SUNDRY NOTICES AND REPORTS ON WELLS
Do not use this form for proposals to drill or to re-enter an abandoned well. Use form 3160-3 (APD) for such proposals.

Devon Energy has just received the CBL for the Bell Lake 24 Fed 4H (30-025-41304) and it shows a low TOC. Devon Energy Production Company, L.P. is respectfully requesting to perform the frac job as scheduled on May 19th and perform remediation efforts within 2 weeks after the completion of the wells on the pad. Today we are going to pressure test the 9-5/8" by 7" annulus to 1000 psi. Based on the CBL, Devon does not believe it will hold pressure.

Cement Remediation

LEASE / WELL:
BELL LAKE 24 FED 4H
COUNTY / STATE:
LEA, NM

WELL SKETCH:
PROPOSED COMPLETION
ZONE:
2nd BS

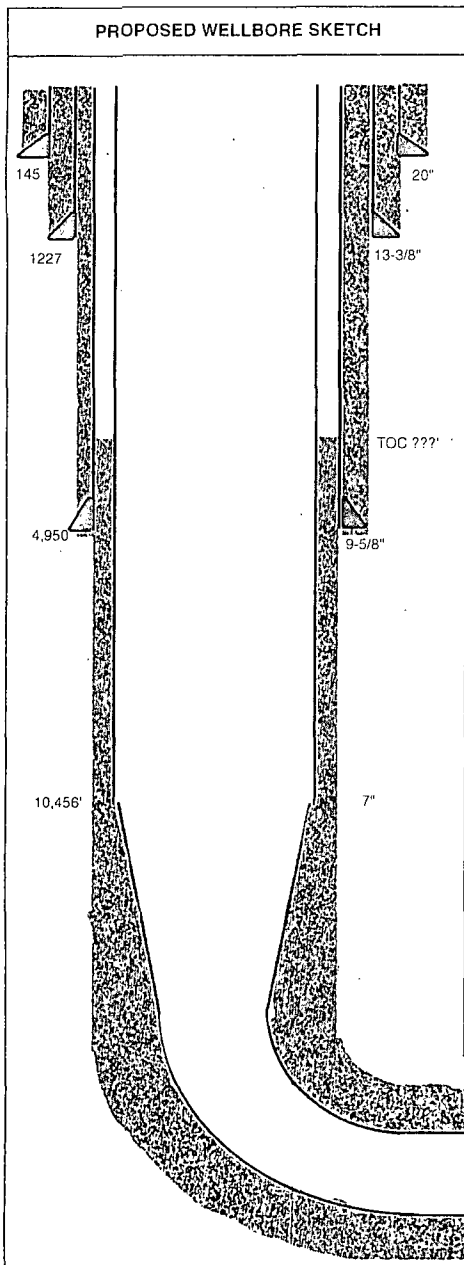
TOC: 5125'
Intermediate shoe: 4950'

If the annulus does not hold pressure, my plan is as follows:

1. Establish an injection rate and pressure. Record information and send to engineer.
2. MIRU frac equipment. Actively monitor and record the 9-5/8" x 7" annulus. Have the pressure transducer hooked up in the frac van and able to be monitored remotely. If pressure exceeds 750 psi shut down the job immediately and contact the engineer.

3. Continue frac as planned. RDMOL frac equipment. MIRU CTU and drill out plugs. RDMOL.
4. MIRU WL and set packer @ 10,500'. Set RBP @ 7000'. Dump 50# sand on top of RBP. RDMOL.

5. Based on injection rates and pressures - develop volumes for a bradenhead squeeze.
6. MIRU cmt crew. Perform bradenhead squeeze not to exceed 1000 psi and/or 5 BPM. RDMOL. Shut well in for 48 hours.

7. MIRU WL. Run CBL @ 1000 psi from RBP to 500' above new TOC. Repeat entire run with 0 psi. Confirm new TOC. RDMOL WL.
8. Pressure test annulus to 1000 psi for 30 minutes and record on chart. Send CBL, post-job cement report, and chart to the BLM.

9. MIRU PU. RIH w/tbg. Circulate sand off RBP. POOH with RBP.
10. RIH w/tbg sting into pkr. Retrieve plug set in pkr. RDMOL PU. Release to production.

Approved As Written
